New Primary School at Warnervale for SSD Application

Strategic Design (Pre-Construction) Road Safety Audit

12 December 2019

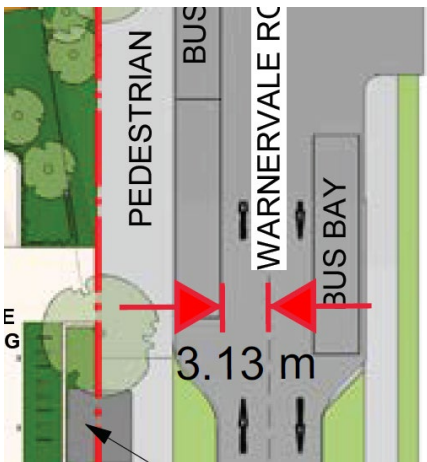
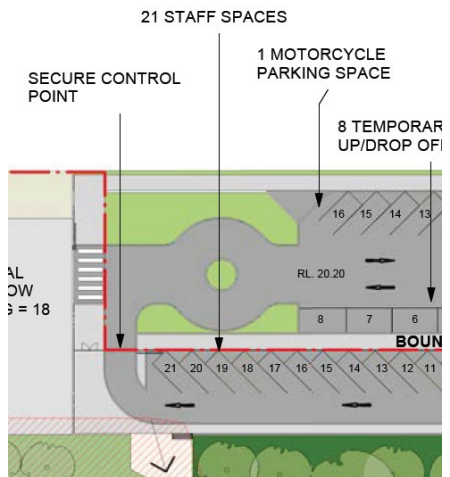
| Item No. | Location | Descriptions of Findings | Design | Likelihood | Severity | Risk Rating | Designer Response |
|----------|--|---|--|------------|----------|-------------|-------------------|
| 1. | Proposed roundabout on Warnervale Road | <p>The proposed roundabout is located on a crest. Motorists' sight lines may be compromised and hence not expecting a roundabout on Warnervale Road.</p> <p>Furthermore, the design does not include a splitter island on any approaches to the roundabout to enhance visibility to the roundabout and deflect vehicles to curve around the roundabout island.</p> <p>Risk of motorists travelling straight through the roundabout island resulting in conflicts with other vehicles.</p> |  <p>Diagram above: strategic design of the roundabout</p>  <p>Photo above: Eastbound approach to the proposed roundabout location</p>  <p>Photo above: Westbound approach to the proposed roundabout location</p> | Occasional | Moderate | Medium | |

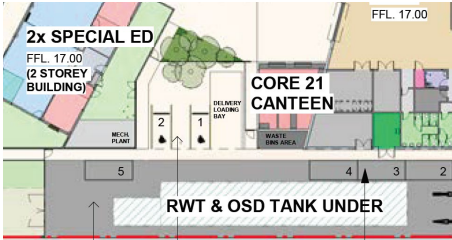
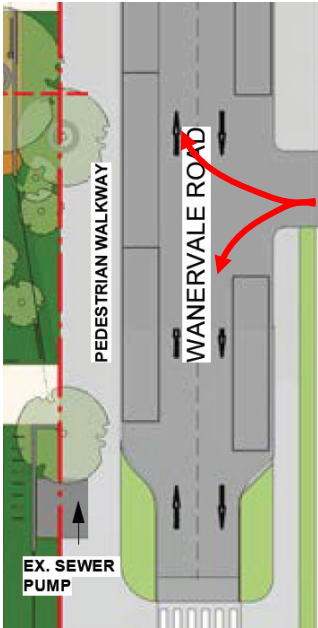
| Item No. | Location | Descriptions of Findings | Design | Likelihood | Severity | Risk Rating | Designer Response |
|----------|---|--|---|------------|----------|-------------|-------------------|
| 2. | Proposed pedestrian crossing on Warnervale Road | <p>It is not clear whether lighting would be provided directly above the proposed pedestrian crossing on Warnervale Road.</p> <p>Insufficient level of illumination at a pedestrian crossing increases risks to pedestrians as motorists may not sight the crossing facility and the pedestrians on it during the night-time.</p> |  | Improbable | Major | Medium | |
| 3 | Proposed roundabout on Warnervale Road | <p>Warnervale Road on approach to the new roundabout comprises one travel lane. The new roundabout on Warnervale Road comprises two circulating lanes.</p> <p>Provision of two circulating lanes through the roundabout is unnecessary and may lead to lane change movements and motorists not reducing their travel speed whilst on the roundabout.</p> |  | Improbable | Major | Medium | |

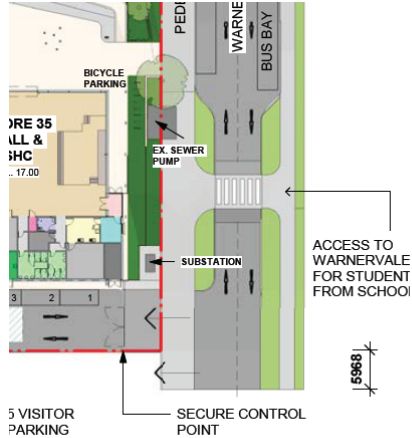
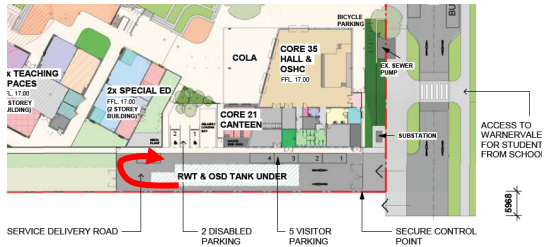
| Item No. | Location | Descriptions of Findings | Design | Likelihood | Severity | Risk Rating | Designer Response |
|----------|---|--|---|------------|----------|-------------|-------------------|
| 4. | Proposed pedestrian crossing on Warnervale Road | <p>The proposed pedestrian crossing on Warnervale Road is located away from the main school entrance.</p> <p>Consequently, students alighting a bus at the westernmost bus stop on the north side of Warnervale Road may not use the proposed pedestrian crossing and may take the shortest route across Warnervale Road which may lead to incidents with vehicles on Warnervale Road.</p> |  | Improbable | Moderate | Low | |
| 5. | No. 50 Warnervale Road driveway | <p>The distance between the existing driveway of No. 50 Warnervale Road and the roundabout is approximately 3m which is less than the minimum requirement of 6m according to AS2890.1.</p> <p>In addition, there are no physical measures to prevent vehicles turning right into and out of the driveway adjacent to the roundabout.</p> <p>Risk of a vehicle entering the roundabout circulation lane directly from the No. 50 Warnervale Road driveway. This would increase traffic conflicts at the roundabout.</p> |  | Improbable | Moderate | Low | |
